SUNDRY NOTICES AND REPORTS ON WELLS
Do not use this form for proposals to drill or to re-enter an abandoned well. Use Form 3160-3 (APD) for such proposals.

8. Well Name and No.
Hale 11 Federal #2

9. API Well No.
3001525832

Hale 11 Federal 2
30-015-25832
Matador Production Company
January 20, 2016
Conditions of Approval

PROPOSED

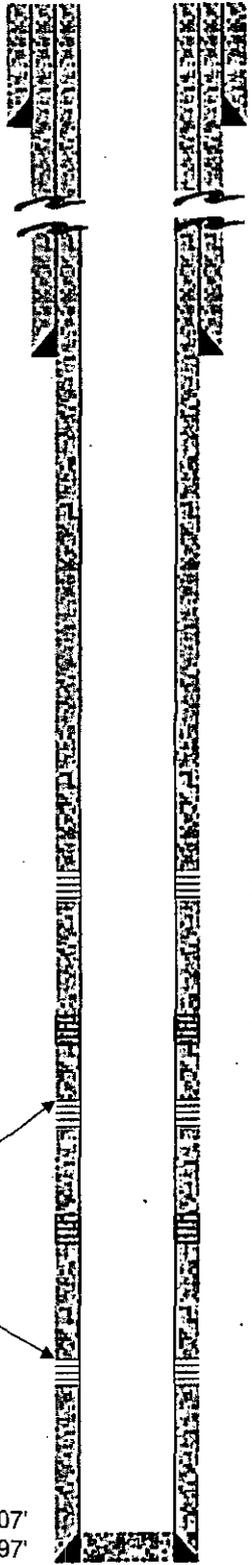
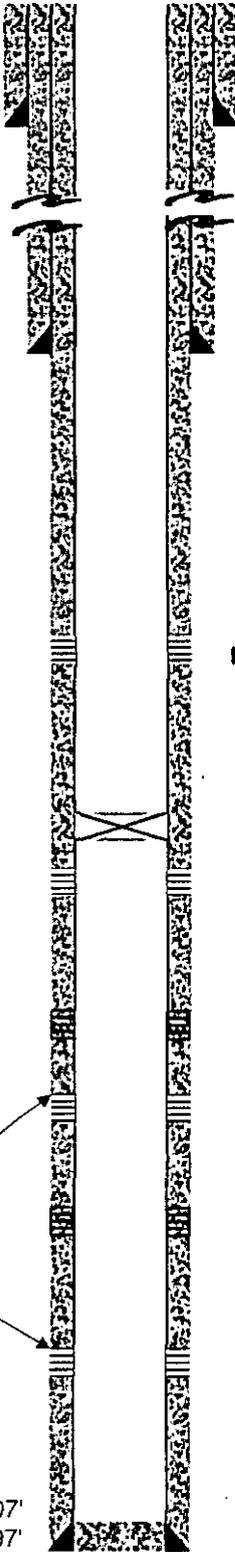
CIBP @ +/- 8,700'

- 1. Operator shall place CIBP at 8,036' (50'-100' above top most perf) and place 25sx of Class H cement on top. WOC and tag.**
- 2. Must conduct a casing integrity test before perforating and fracturing. Submit results to BLM. The CIT is to be performed on the production casing to max treating pressure. Notify BLM if test fails**
